SERVICE PROCEDURE

22524 / 22534
JANUARY, 2023

SUBJECT: SAFETY RECALL 22524 Variation 22534
Hex Flange Lock Nut on certain International® HV™
and MV™ Series trucks built 02/24/2022 thru
08/16/2022 and certain IC Bus® CE commercial
buses built on 02/28/2022.

Figure 1. TRW Pitman Arm Nut

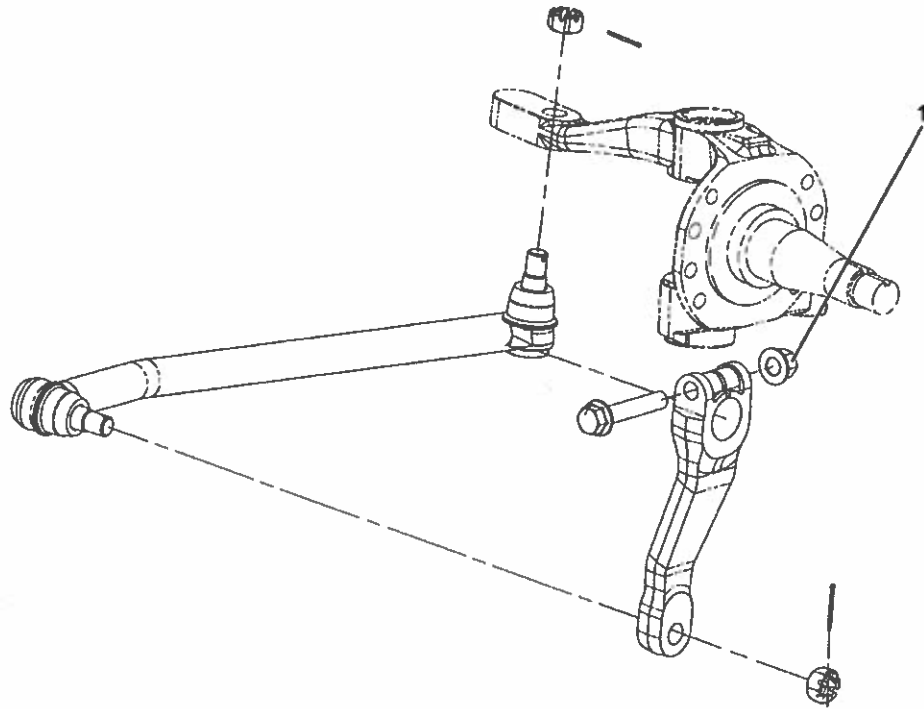
A specific hex flange lock nut used in several, but not all, steering and / or suspension locations may have not been properly formed and heat treated to Navistar's specifications and can result in a loss of joint tension as the vehicle ages. A loss of joint tension in these joints may affect vehicle handling and could contribute to a vehicle crash.

6. Access Pitman arm nut (Figure 1, Item 1).

NOTE: After installation of each nut, ensure at least one thread is protruding past the top edge of the nut.

7. Remove and replace nut. Using a torque wrench and backup wrench positioned on bolt, tighten nut to 330-370 lb-ft (450-500 N·m).
8. Close and latch hood.
9. Remove wheel chocks.
